MEADOW GROUNDS DAM,

(NDS LD. <sup>Number</sup> PA - 00185,

PHASE I INSPECTION REPORT.  
NATIONAL DAM INSPECTION PROGRAM

11 AUG 1979

PHOTOGRAPH 8 Downstream view of spillway channel from weir crest.

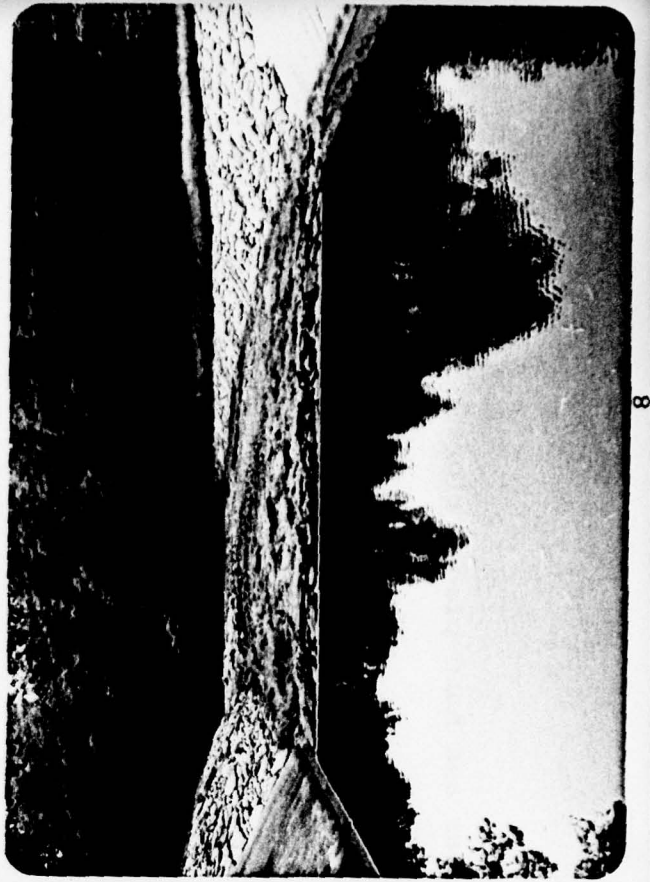
1. Spillway. Visual inspection revealed the spillway to be in good condition (see Photographs 6 and 7). No obstructions or concrete deterioration were observed. The channel immediately downstream of the stilling basin is adequately protected by hand-placed and/or dumped rock riprap (see Photograph 8).

PHOTOGRAPH 11 View of outlet endwall and stagnant pool.

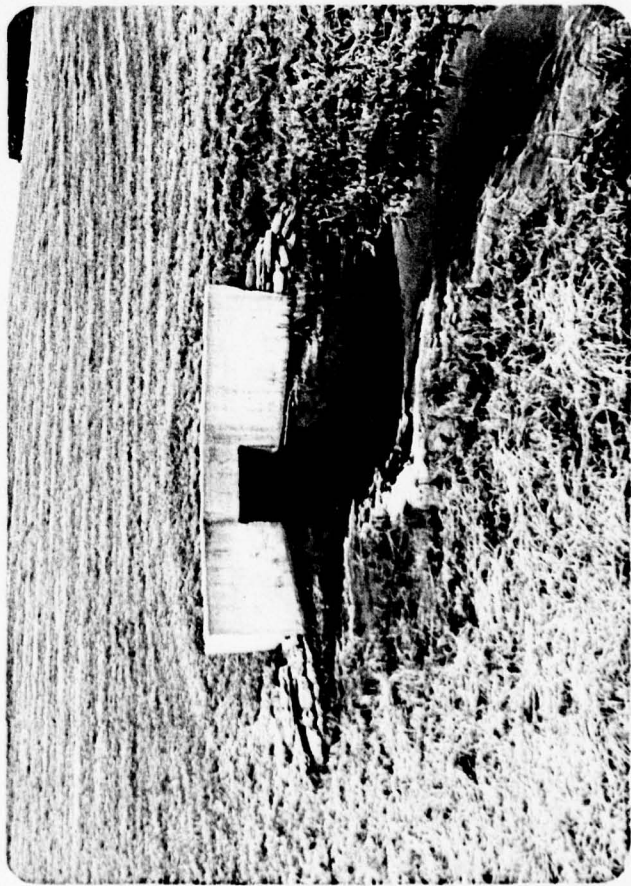
2. Outlet Works. Visible portions of the outlet works were found to be in good condition (see Photographs 9, 10, and 11). No concrete deterioration was noted on the control riser or outlet endwall. The interior of the outlet conduit was not inspected because of partial inundation and noxious conditions attributed to the stagnant pool at the outlet (see Photograph 11). The stoplogs were in place and functioning as designed.

2. Outlet Works. Visible portions of the intake tower and outlet conduit were found to be in good condition. The outlet conduit was not entered due to partial inundation and noxious conditions attributed to stagnant water ponded at the outlet.

a. Evaluate the outlet works channel and take necessary remedial measures to provide unimpeded discharge through the channel.
